ADDENDUM TRAFFIC IMPACT STUDY

**SECTION OF LOTS 7,8 AND 9, CONCESSION 10
TOWNSHIP OF PUSLINCH
COUNTY OF WELLINGTON**

CFCA FILE NO. 2433-6646

D14-KUK – 4th Submission Comment Summary

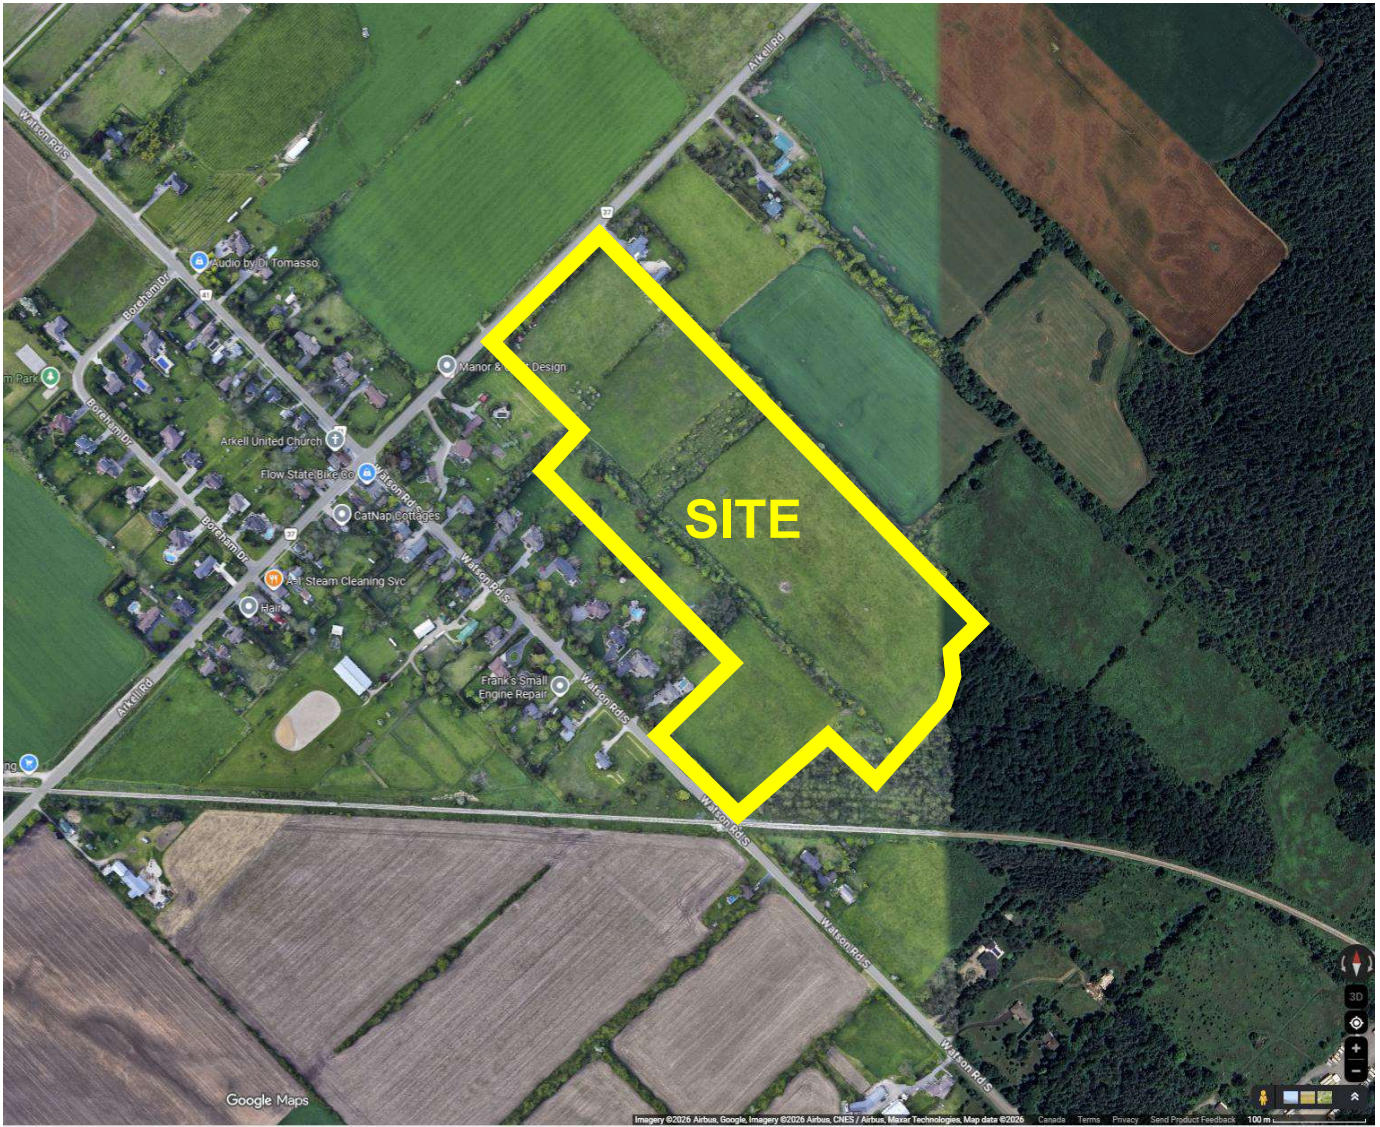
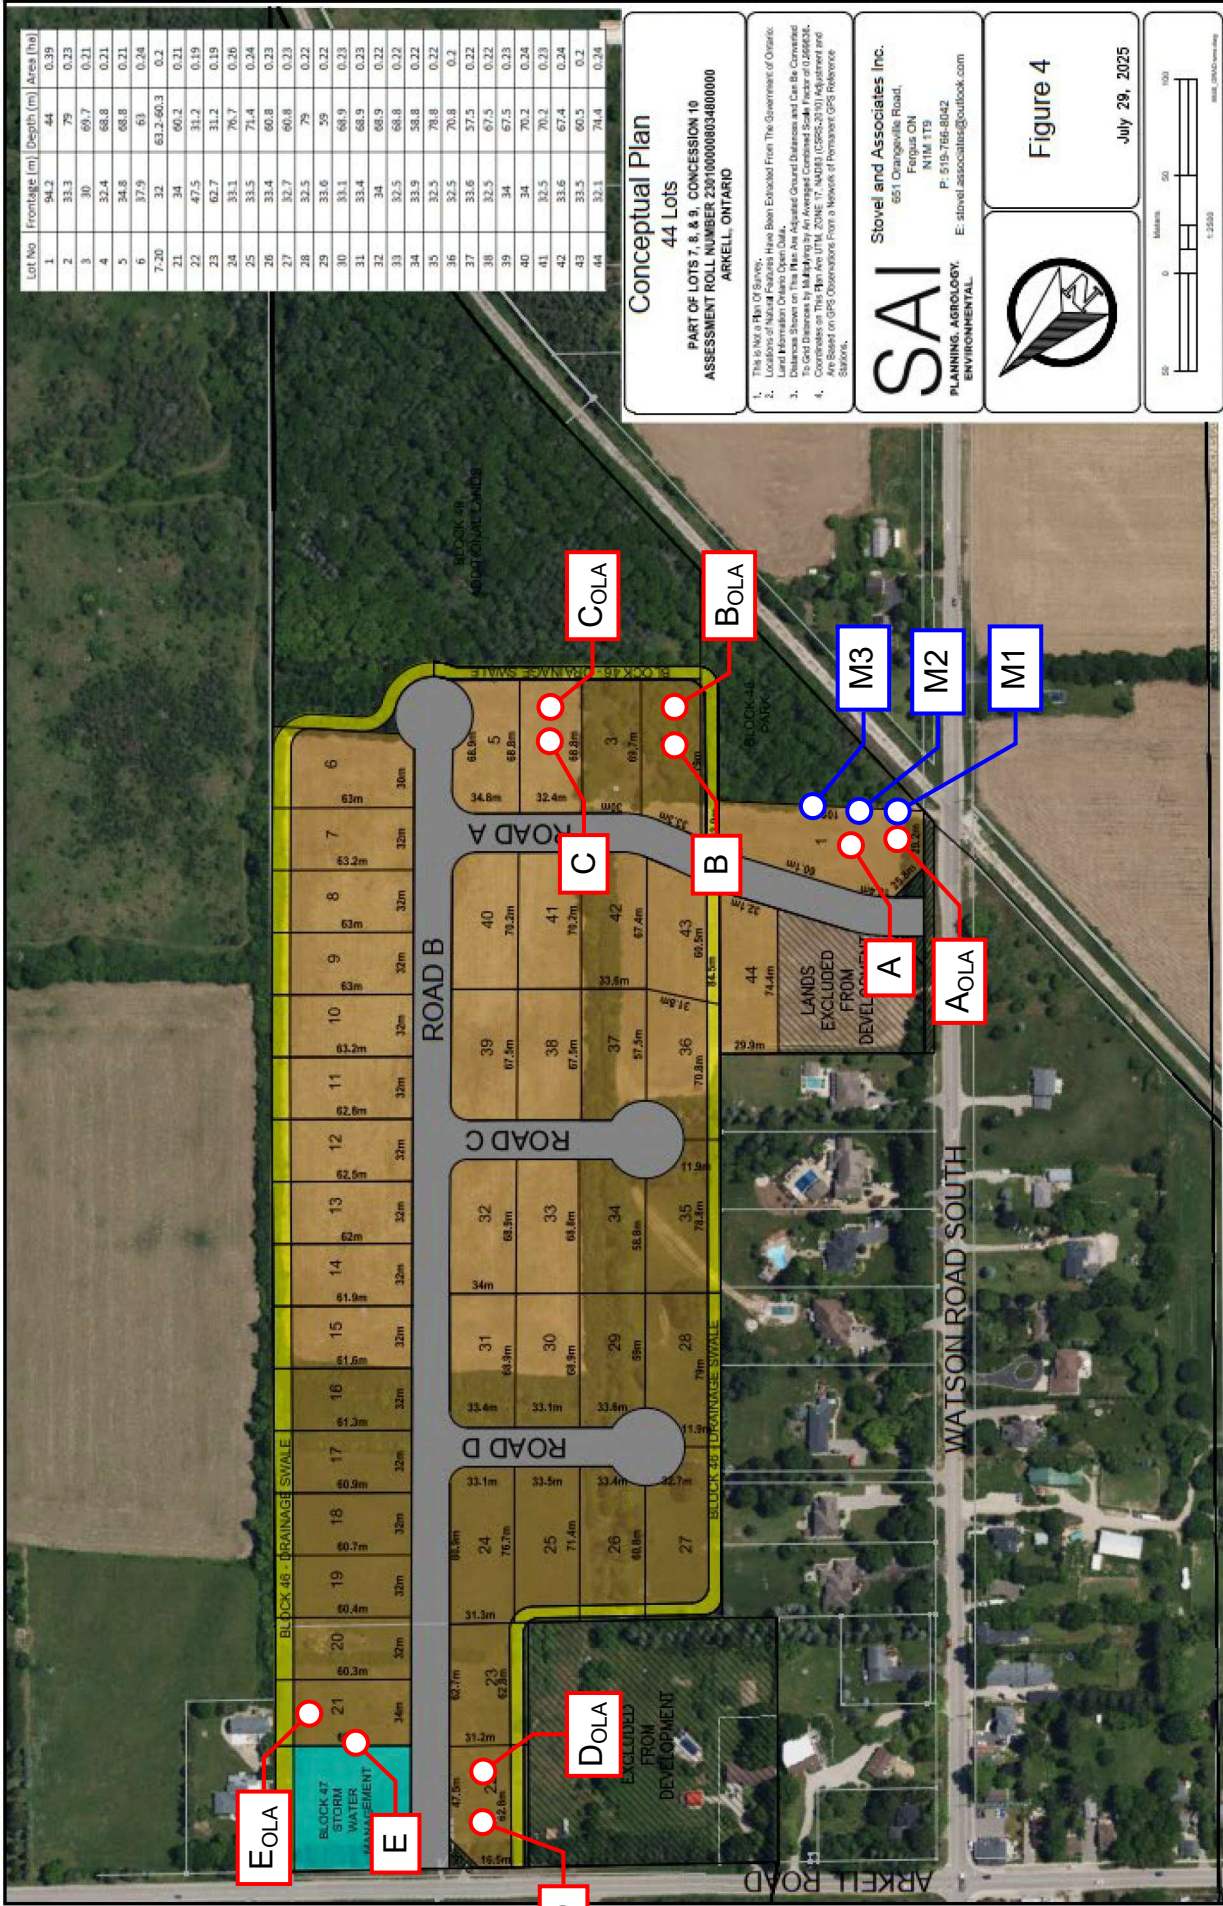
- iii. Figure 1 outlines the extent of the proposed development that is subject to the evaluation of this study and Figure 2 shows locations of potential noise receptors. This is, however, different from the extent of lands subject to the ZBA application as detailed in the schedule of the draft Zoning By-law. Please ensure alignment between the extent of the study area of the NVFS and the extent of lands subject to the proposed ZBA application;

Figure 4: Proposed Concept Plan Showing Ventilation and Acoustic Barrier Requirements

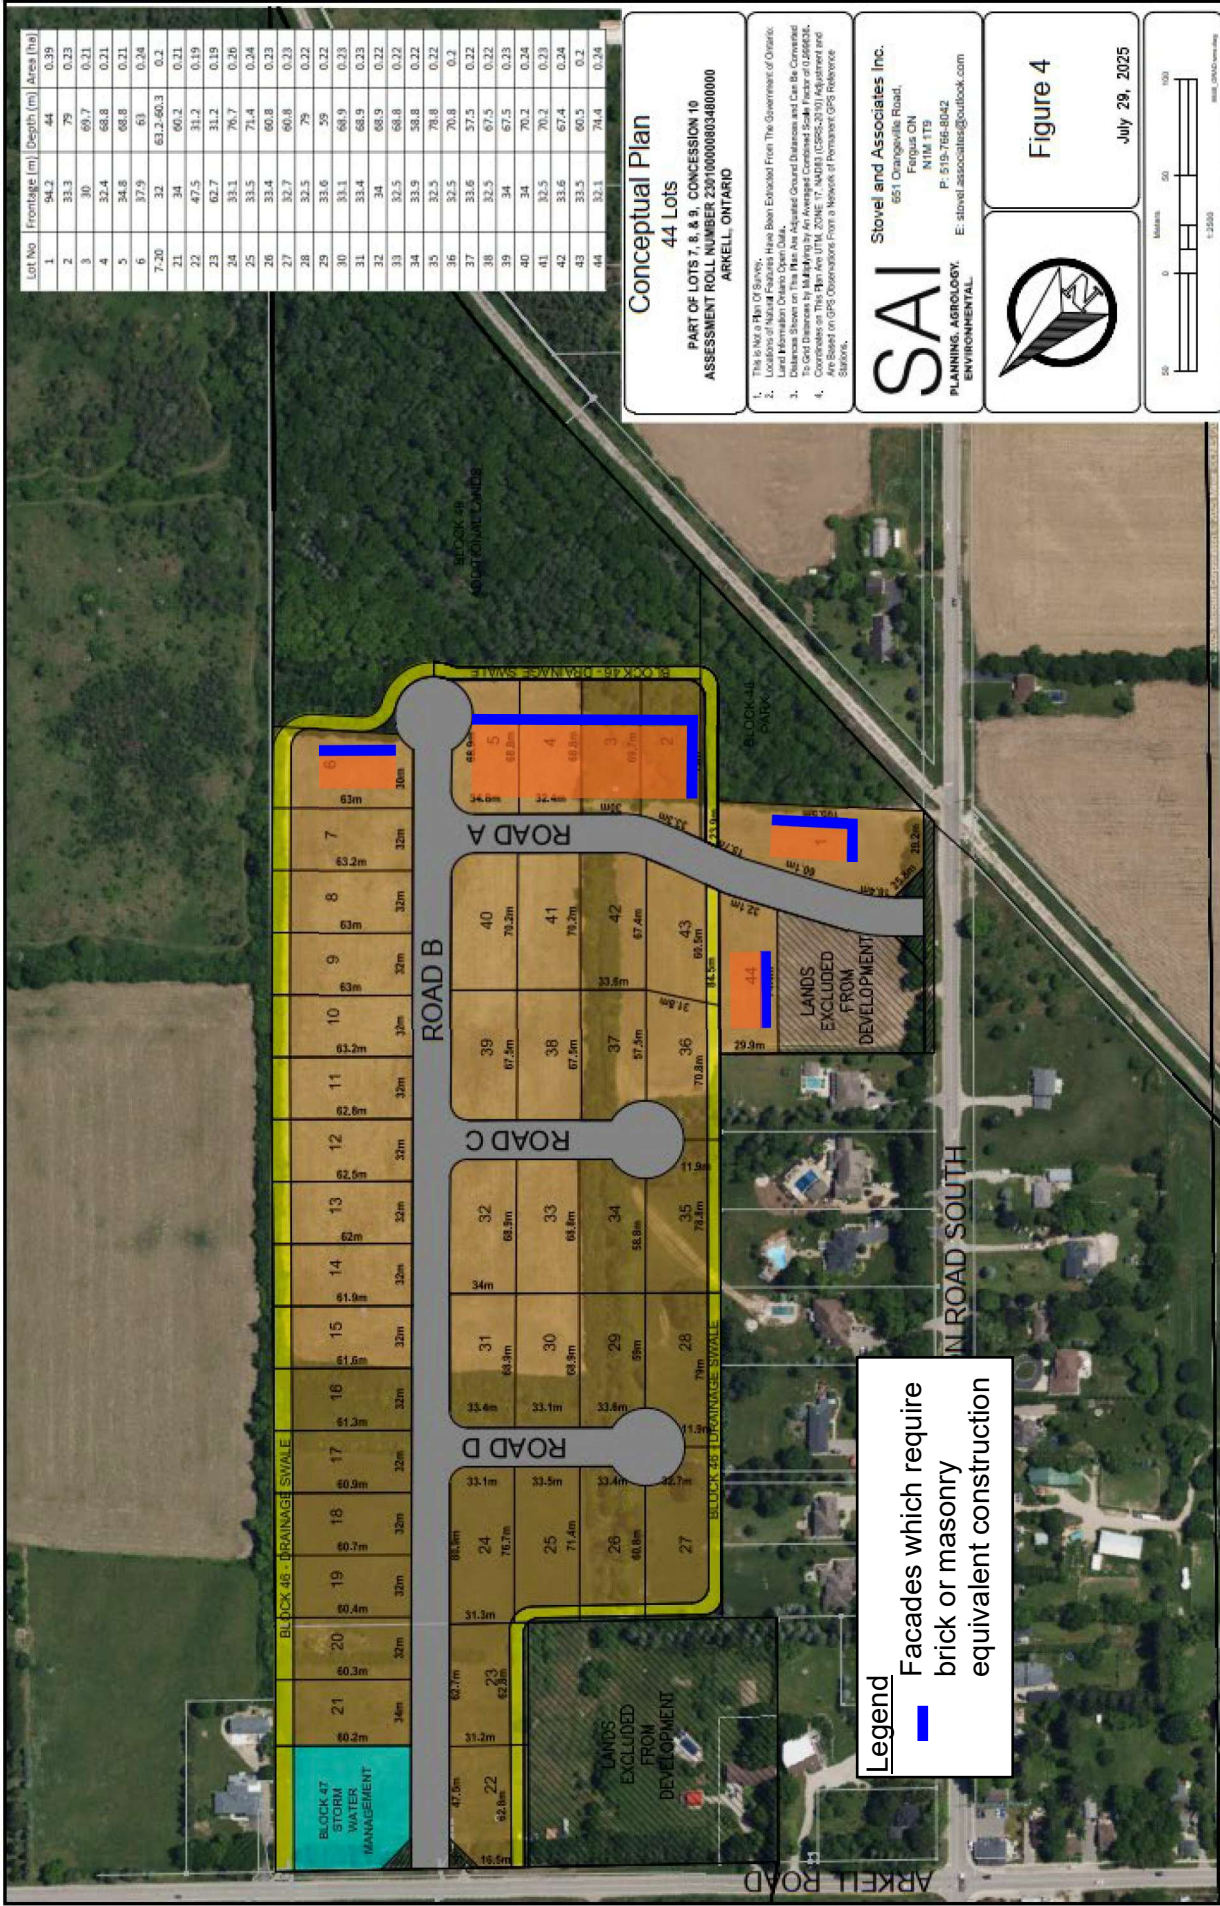
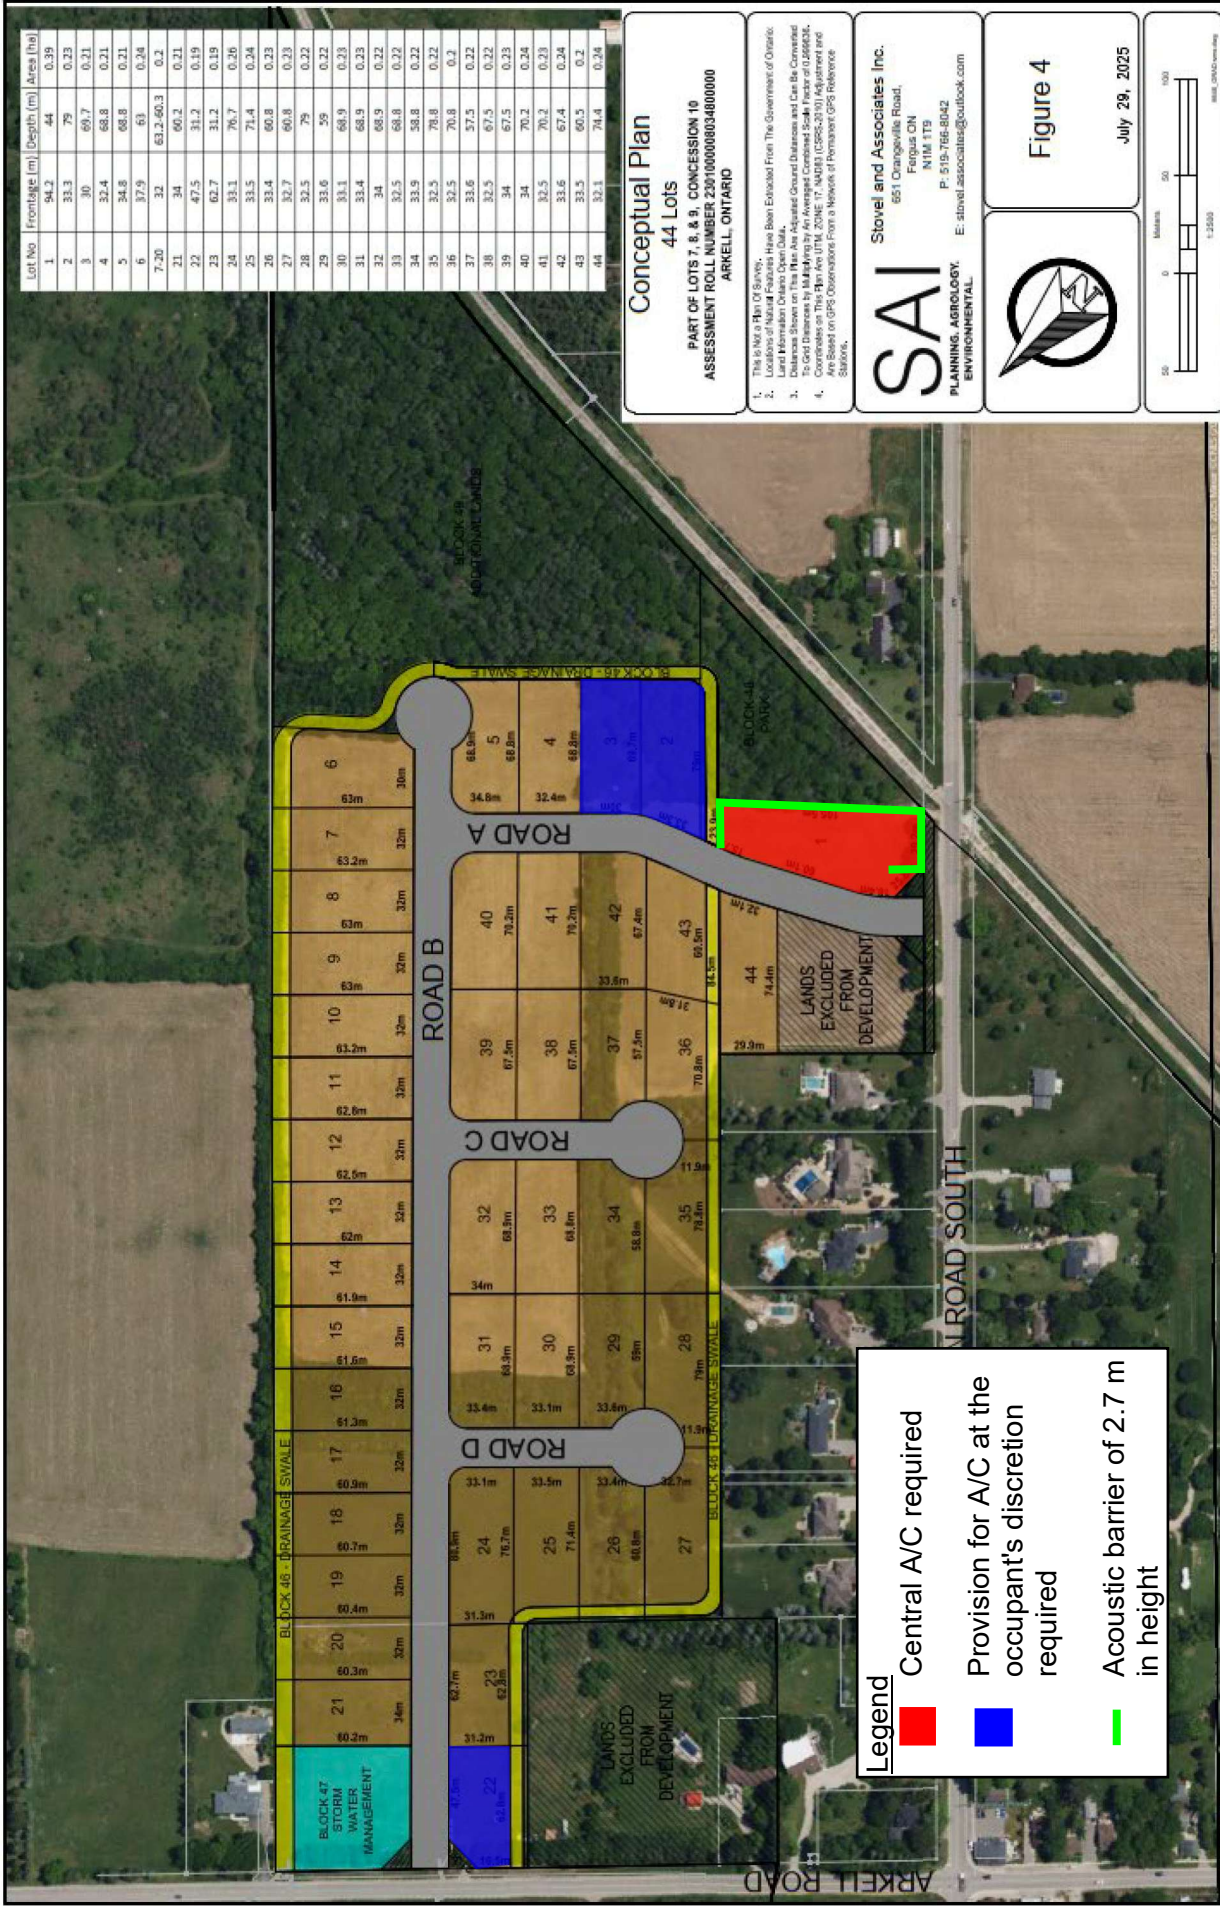
- v. Part of the proposed 2.7-metre-high acoustic barrier for Lot 1 is located at the southwest corner of this lot. Please confirm that this barrier does not lie within the required sight triangle for this lot. Otherwise, either a zoning amendment to provide relief from section 4.26 of the Puslinch Zoning By-law or this recommendation should be revised to comply with the Zoning By-law; and

- f. The noise mitigation summary provided as Table 7 should include the locations where brick veneer or equivalent masonry construction is required for the exterior walls. Review of the recommended locations shown on the first Figure 4 indicate that in addition to the southeast façade, the southwest façade should also be brick veneer or equivalent masonry construction.
